# Payson Park

## Town of Belmont ADA Transition Plan

August 2021

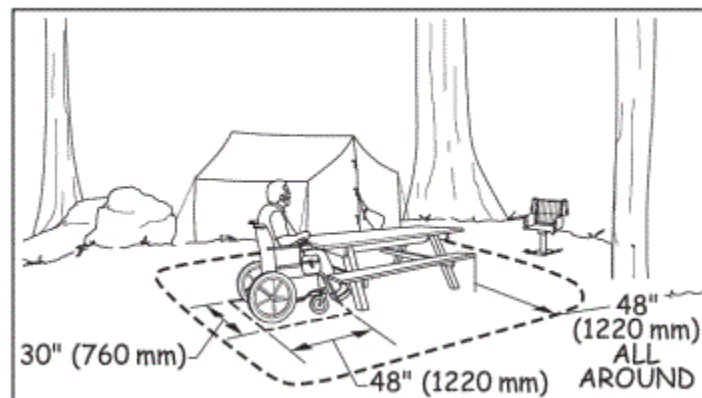
Accessibility issues include lack of an accessible route to and around the two playgrounds. There is also a lack of an impact-attenuating accessible route to the play components inside the boundary of the playgrounds. See the following diagram depicting accessible routes to and around the playgrounds from entrances (in yellow) and to the play components in the playgrounds (in red). A stone dust route to the bike rack is shown in light blue.

- Install an accessible route to and around the playgrounds: \$19,620
- Provide an accessible impact-attenuating surface to and around each play component in each playground: \$58,338
- (Miscellaneous corrective actions: directional signs, etc.):\$1,692

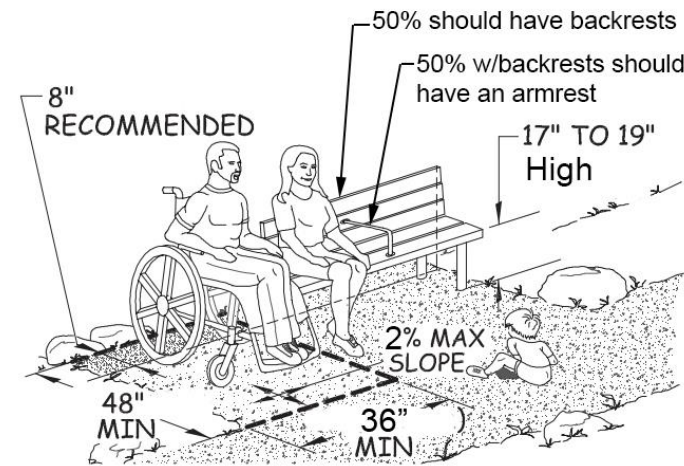
- IHCD strongly recommends exploring the possibility of an alternative surface to engineered wood fiber (EWF). Over time, EWF requires continuous maintenance to ensure the surface is maintained in operable working condition (stable, firm and slip-resistant). In addition, when used in combination with other surfaces required for accessible routes to play components in Massachusetts, it will present a challenge to prevent level changes at the transition points between EWF and other surfaces, and to keep the accessible routes clear of EWF.
- Recommend providing a 48" wide min. stable, firm and slip resistant surface under and around an accessible picnic table once it is placed in the picnic area and connected to an accessible route. See the following diagram:

- Recommend providing clear floor space of 36" wide minimum by 48" deep alongside at least one bench that is located on an accessible route so that a wheelchair user can sit with their shoulders aligned alongside someone sitting on the bench. See the following diagram:
